NEW PhotoEye Retrofit Kit for StrongArm M30-M50

SUBJECT: New photoeye retrofit kit

PRODUCTS AFFECTED: M30 and M50 StrongArm Operators

FIG-1: P/N MX5803, NEW PhotoEye Enclosure Kit

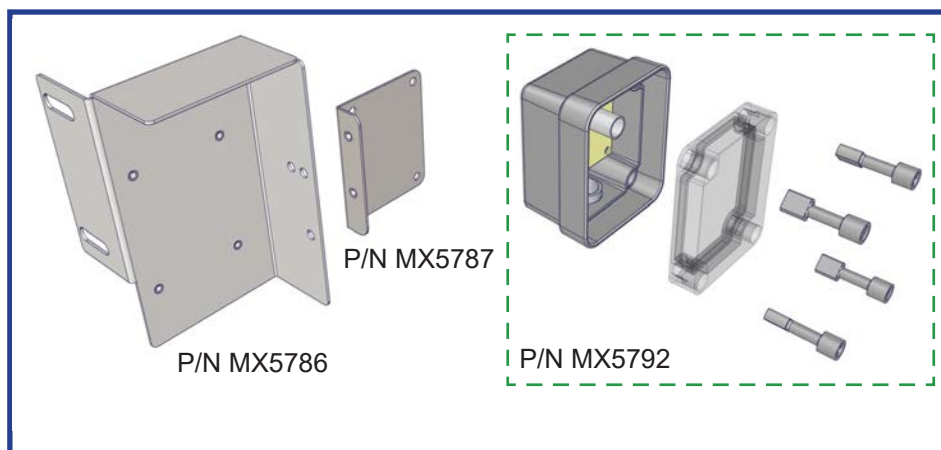
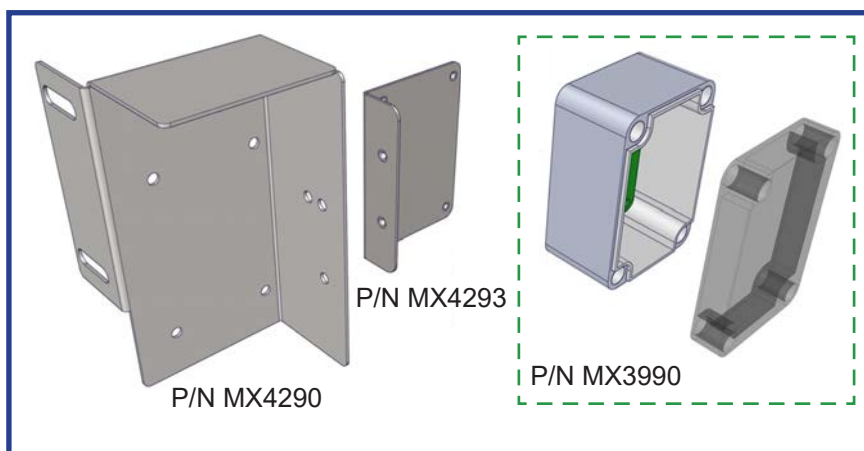
IMPACT: Change to enclosure part numbers and sizing, but features, function, and wiring unchanged

A new photoeye retrofit kit (P/N MX5803) has been released for use on M30 and M50 StrongArm Crash operators. The original photoeye (MX3990) is now obsolete, and this kit replaces the existing brackets and hardware to accommodate the new photoeye (MX5792-02) in existing Strong Arm Crash Operators.

1. Discard any old parts (see FIG-2, MX4290, MX4293, & MX3990).
2. Replace with new MX5803 kit parts (see FIG-1, MX5786, MX5787, & MX5792-02).
3. Wire photoeye the same as previously wired.
